Access Compliance Report

Public Rights-of-Way

(Curb Ramps)

Intersection ID: 45130	Main Street: DULIN_CREEK_BV	Cross Street: PLAZA_RD_EXT	Location: NW
ADA ID: 87883C7B392F	Ramp Type: Combination2	Initial Pass/Fail: Fail	Overall Compliance: No Severity Score: 33.75

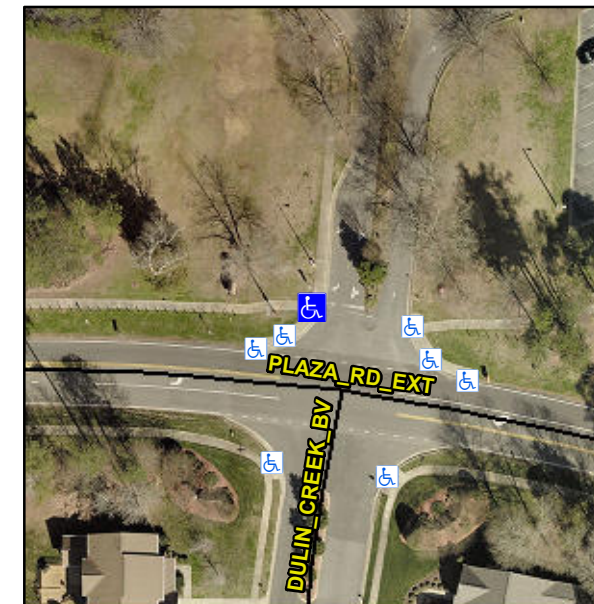
LT RP < 5%

Not Found, R304.5.1, R304.5.3, R304.3.2

Compliance	Description	Data	Compliance	Description	Data
N/A	Ramp Length LT (in)	59.0	N/A	Ramp Length RT (in)	61.0
N/A	Ramp Width LT (in)	36.0	No	Ramp Width RT (in)	36.5
N/A	Ramp Slope LT (%)	1.8	No	Ramp Slope RT (%)	8.5
N/A	Ramp XSlope LT (%)	3.3	No	Ramp XSlope RT (%)	5.3
N/A	Ramp Length (in)	24.0	Yes	Ramp Slope (%)	6.4
Yes	Ramp Width (in)	72.5	No	Ramp XSlope (%)	3.2
N/A	Flare Type LT	N/A	N/A	Flare Type RT	N/A
N/A	Flare Slope LT (%)	N/A	N/A	Flare Slope RT (%)	N/A
N/A	Flare Traversable LT?	N/A	N/A	Flare Traversable RT?	N/A
N/A	Landing Length (in)	N/A	N/A	DWS Provided?	N/A
N/A	Landing Width (in)	N/A	N/A	DWS Contrast?	N/A
N/A	Landing Slope (%)	N/A	N/A	DWS Length (in)	N/A
N/A	Landing X Slope (%)	N/A	N/A	DWS Full Width?	N/A
N/A	Landing Curb? (Y/N)	N/A	N/A	DWS Offset (in)	N/A
N/A	Shared Landing?	N/A			
N/A	Gutter Ponding?	N/A	N/A	Gutter Slope (%)	N/A
N/A	Gutter Lip Ht (in)	N/A	N/A	Gutter X Slope (%)	N/A
N/A	Painted X Walk1?	Yes	N/A	Painted X Walk2?	N/A

Remove & Replace Entire Ramp.
